Arboricultural Consultation Response

Application: 25/0520

Proposal: Construction and operation of a 132kV GIS substation, substation building, associated infrastructure and works.

Site: Land Adjacent to Electric Substation, Celtic Way, Celtic Lakes, Newport, South Wales.

Section 5.11 – Tree Removals

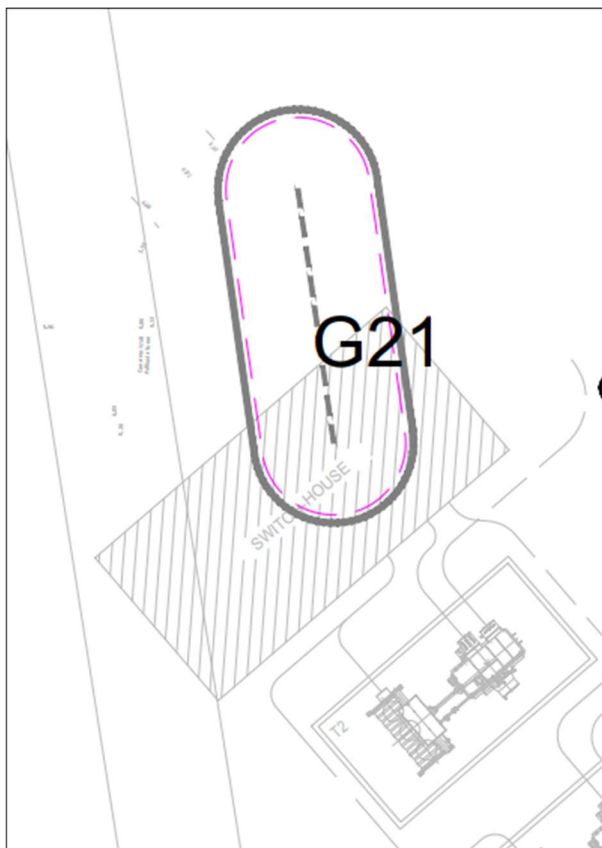
Section 5.11 of the AIA states that *no trees are to be removed to facilitate the development*. However, the proposed 'switch house' shown on the 'June 2025 TPP' clearly shows significant encroachment into G21 (Category C), refer to plan excerpt below:-

These discrepancies must be resolved. Either:

- the AIA must be updated to reflect the removal of G21
or
- the design layout must be revised to align with the AIA and avoid G21 and be reflected within the TPP.

If group G21 is indeed to be removed, the following must be addressed:

1. **Justification** must be provided for why removal is unavoidable.
2. **Consideration of alternatives** is required, including repositioning of the proposed substation to avoid intrusion into Group G21.

If tree removals are accepted, a **minimum replacement planting ratio of 1:3** must be applied.
